CASE/FILE: AR-15-25 (Community Development Dept.: Planning Division)

PROPOSAL	To construct a new restaurant at Nyberg Rivers, Cracker Barrel
-----------------	--

RE: Cracker Barrel at Nyberg Rivers Completeness Response for Architectural Review (AR-15-0025)

SOUTH ELEVATION

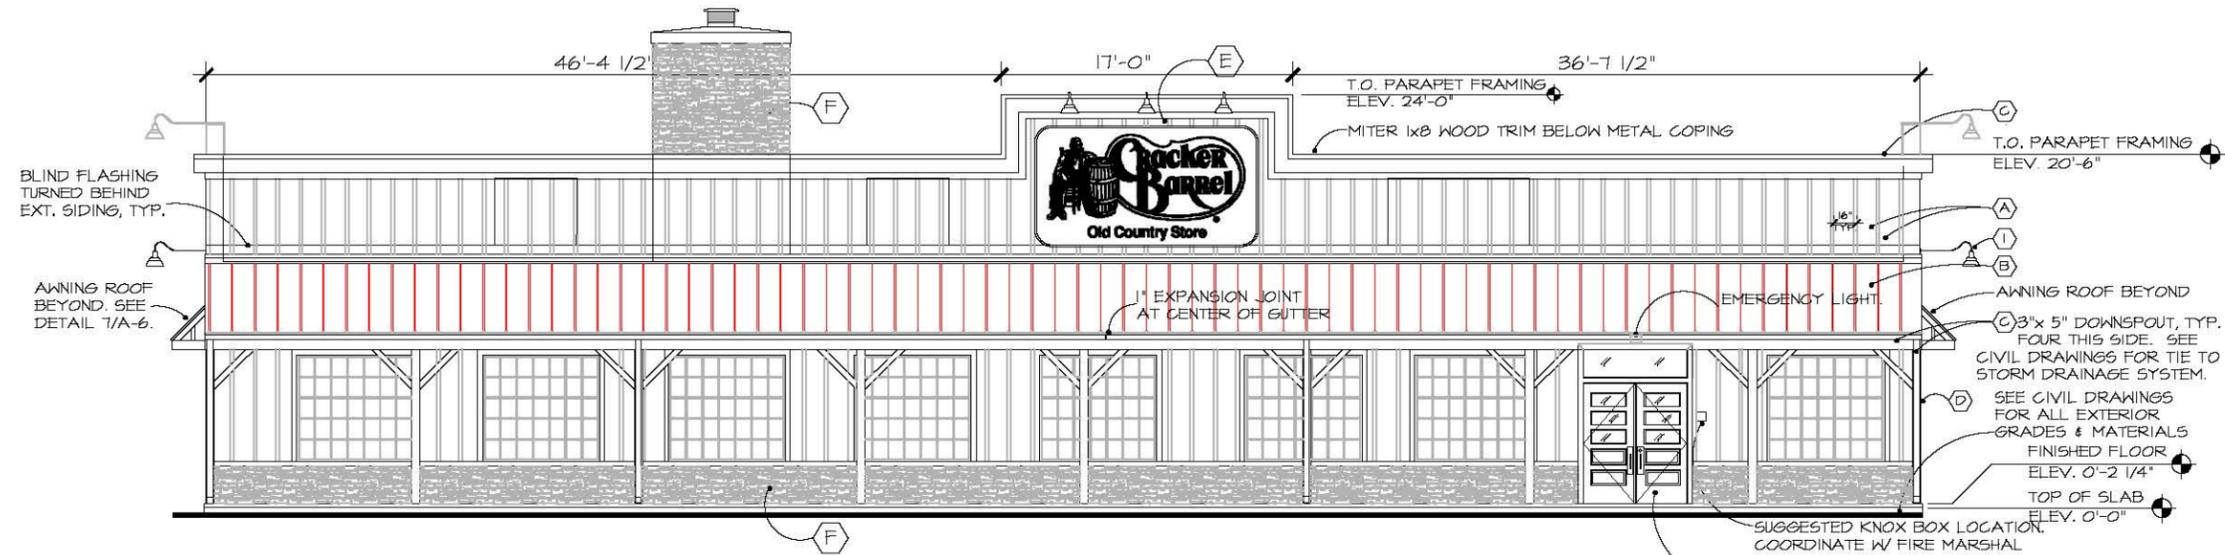
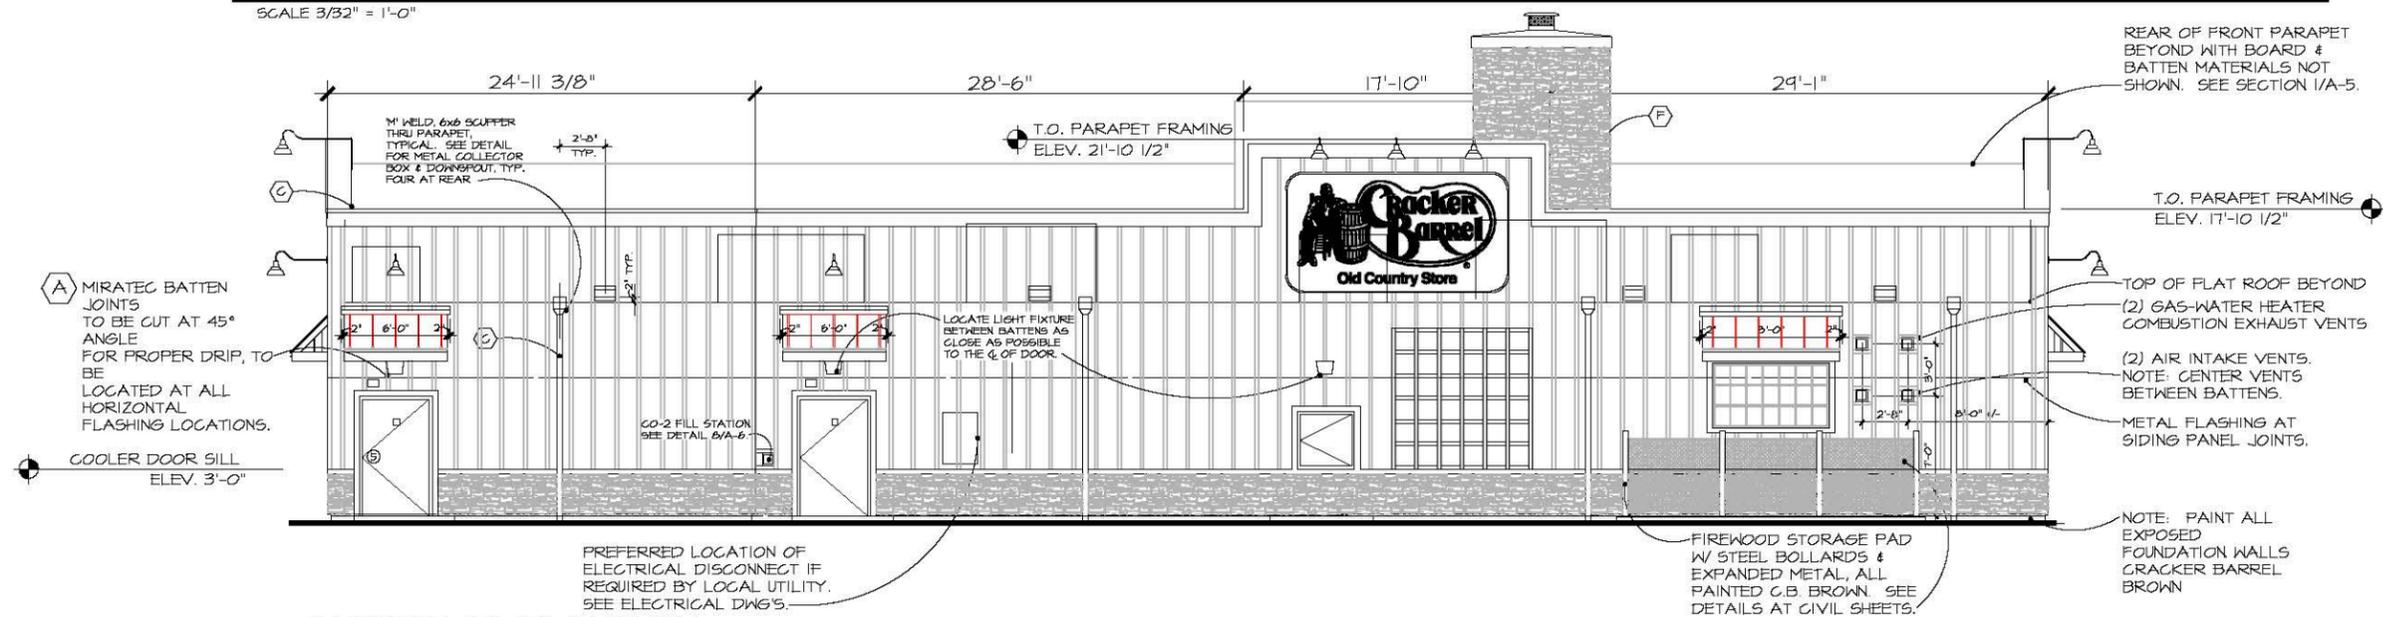
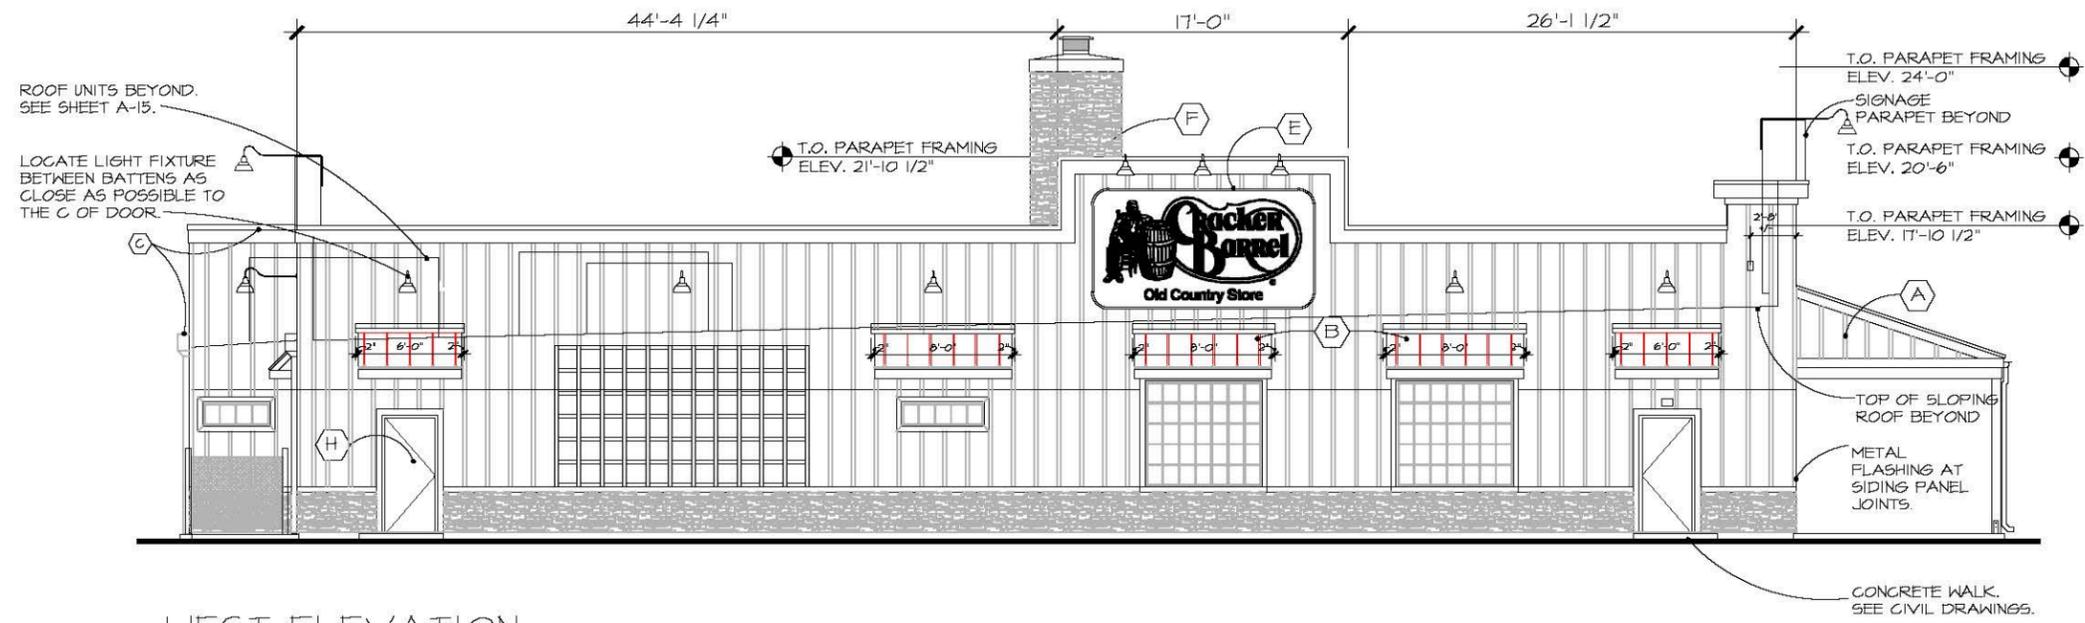
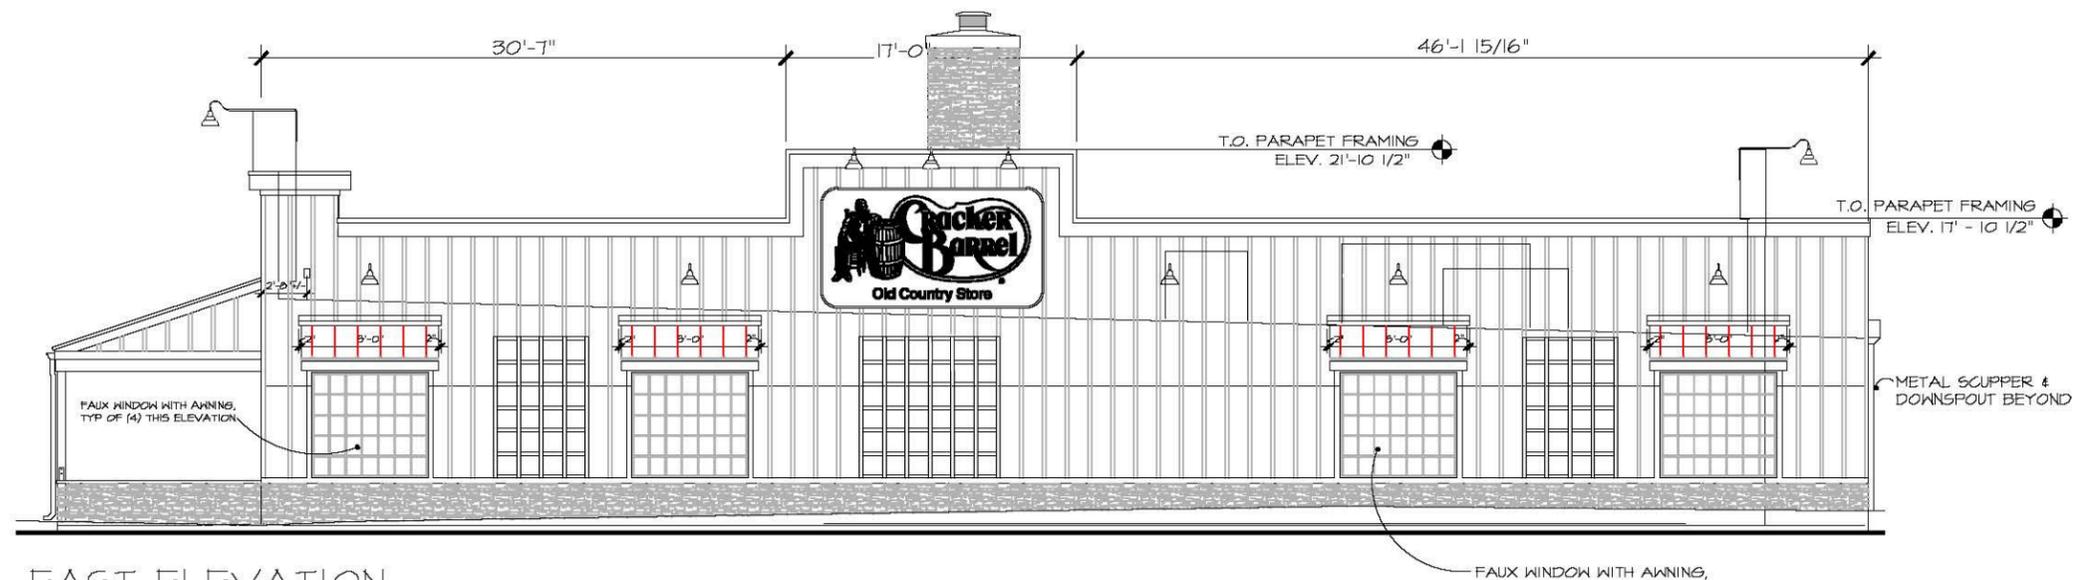
- 2. Please provide color elevations to scale with a material board or sheet that gives specifications for materials, colors, and textures per the checklist.**

Response: Color elevations are provided in the plan set on sheets 001, 002 and D-1 in Exhibit H. A physical materials board providing examples of materials, colors and textures is included with the resubmittal.

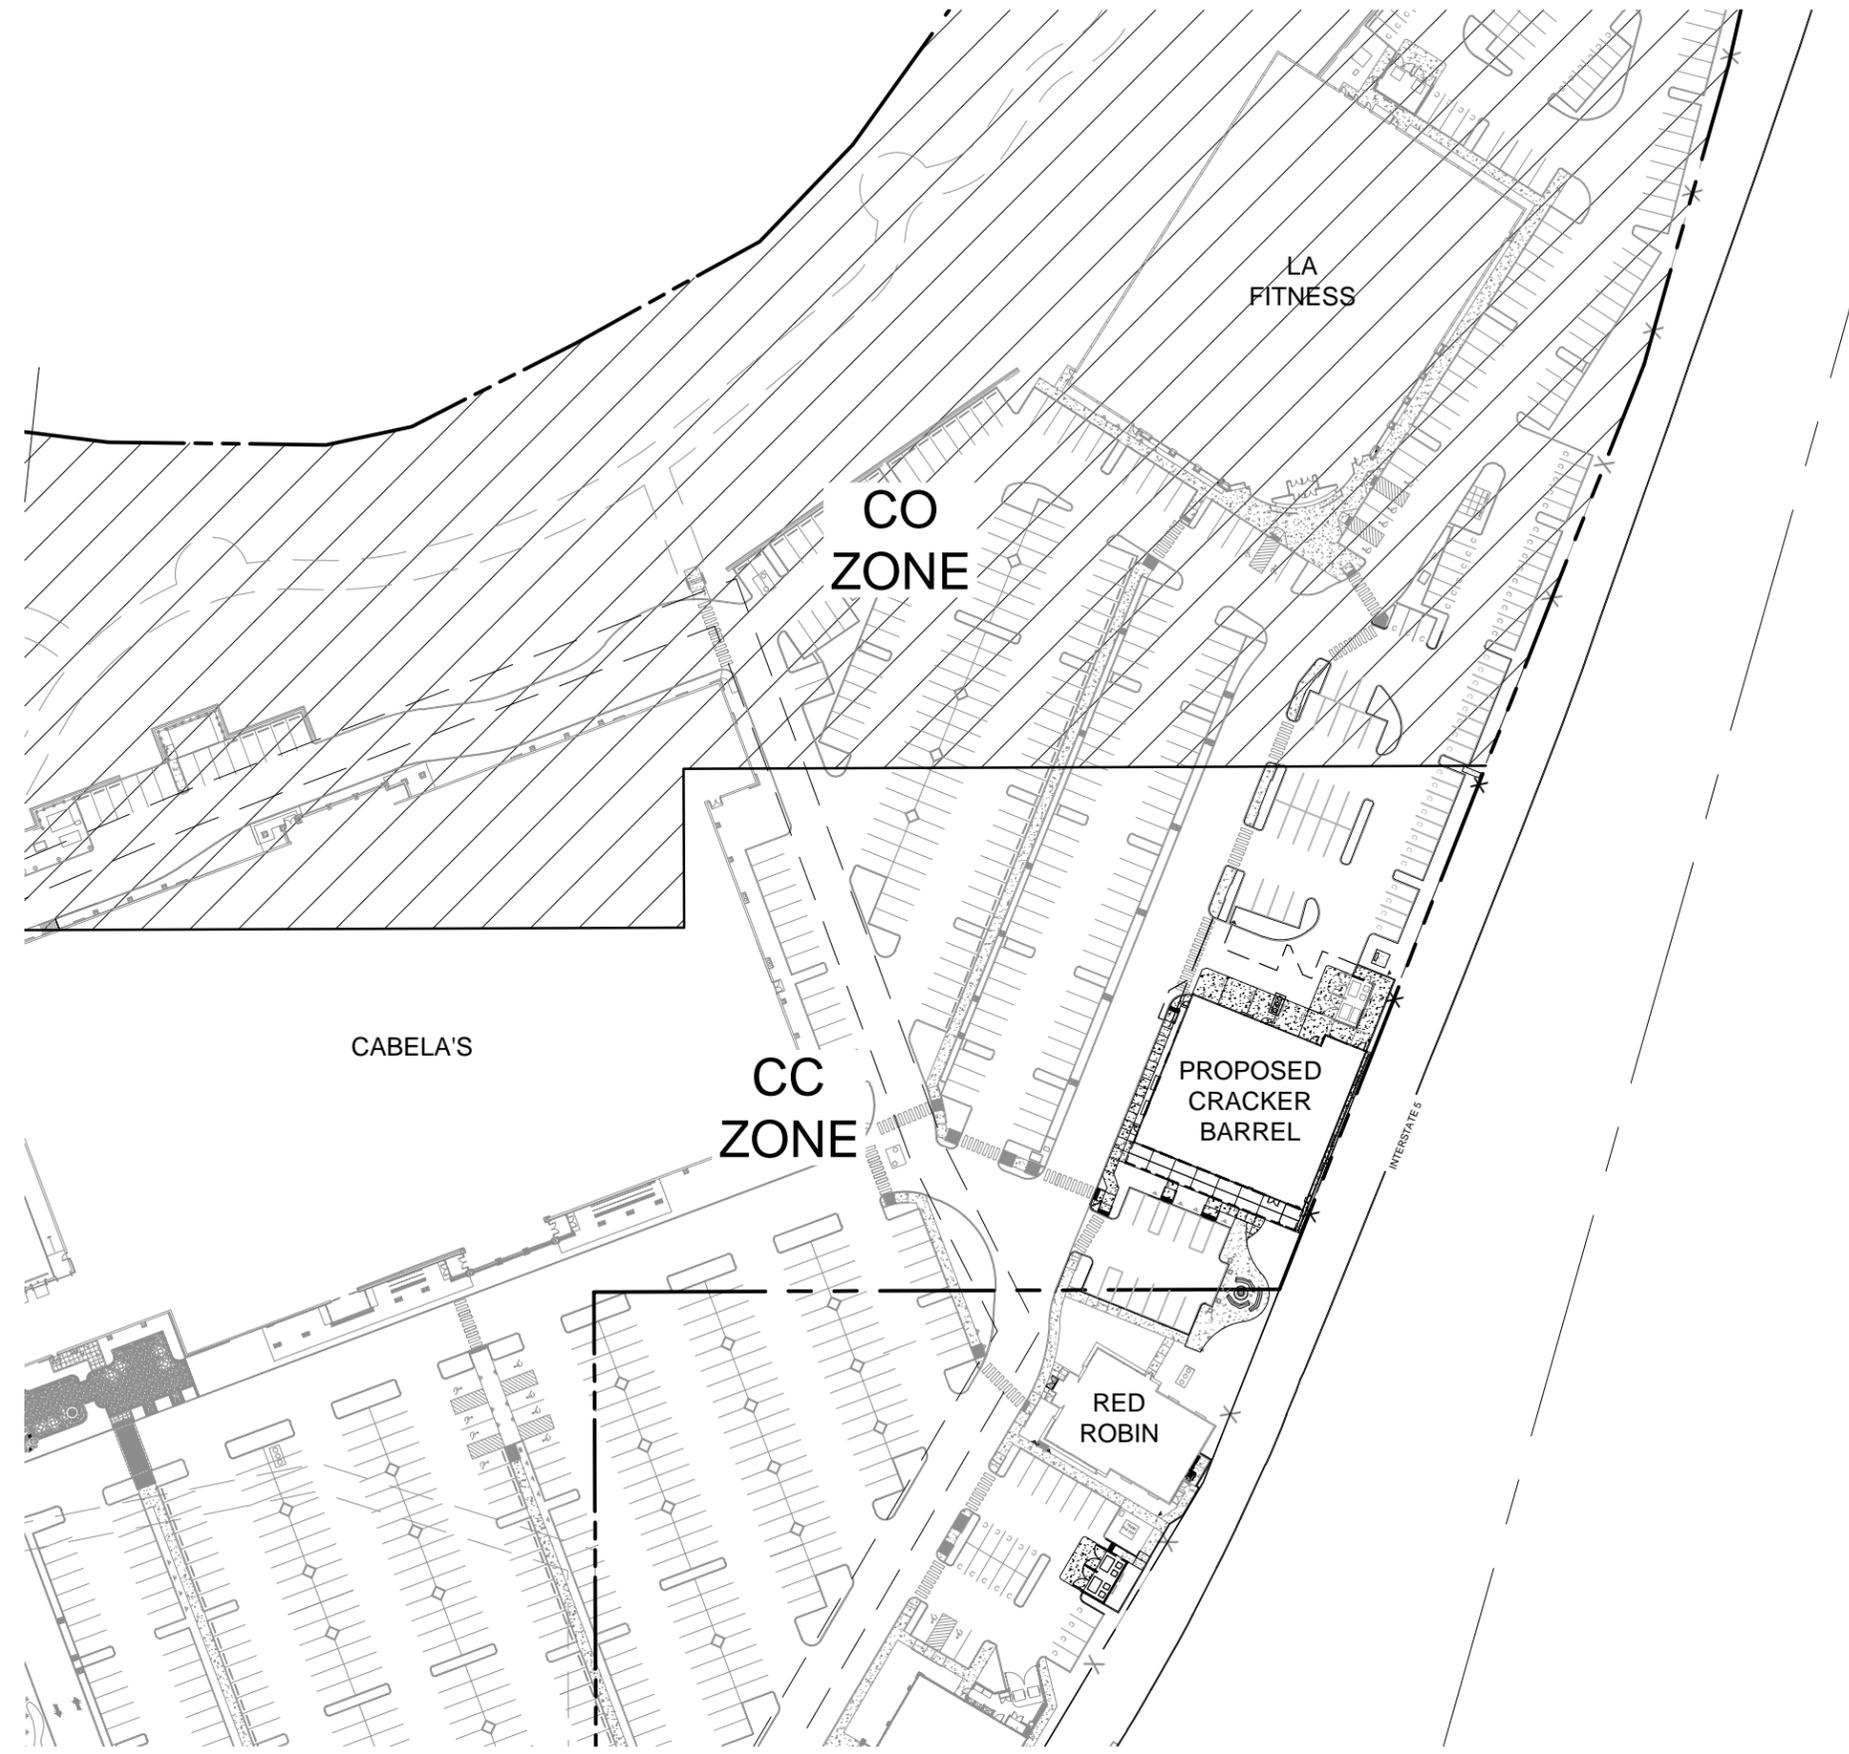
- 5. Please provide an exhibit showing the CC and CO boundary as a layer on top of the proposed site plan. Staff is unsure whether all the proposed work is in the CC zoning district.**

Response: The proposed project is entirely within the central commercial (CC) planning district. Exhibit I shows the site in relation to CC and commercial office (CO) planning district boundaries.
